Publication date	21/10/2015
Document nr.	SUPAIR_2015/10_001
Number of page	1 / 4

## SAFETY NOTE

TOPIC : ALTIRANDO2RS rescue handle release

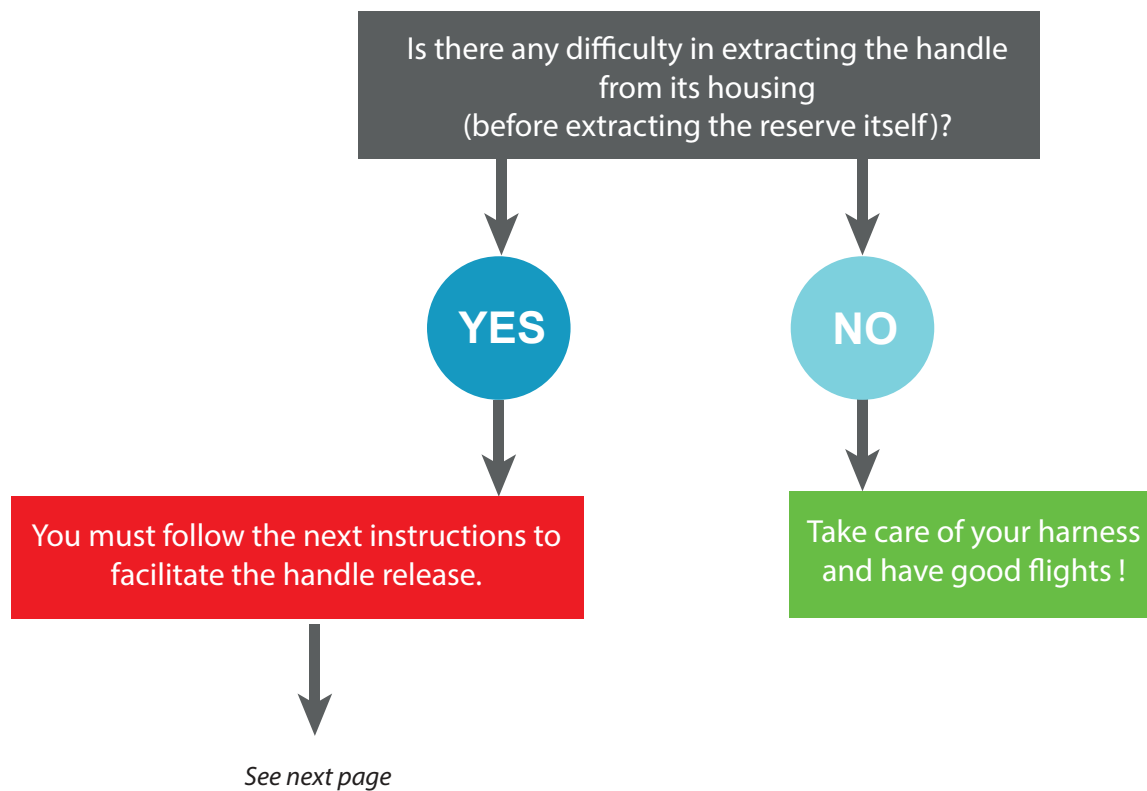
During a hang test, we noted some difficulties in removing the rescue handle from the housing. This is due to the presence of a velcro strap on one of the rescue pocket folds.

3

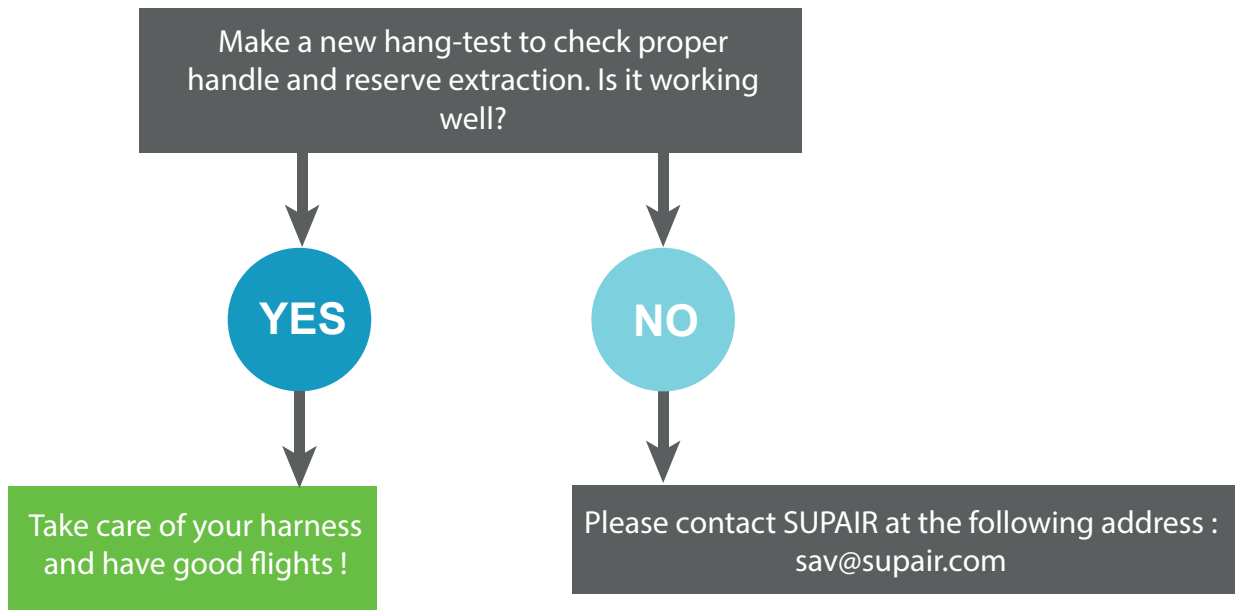
- 2 Make an incision in the Velcro at the "B" end.

The B end is then released.  
(Identical configuration to the "A" end)
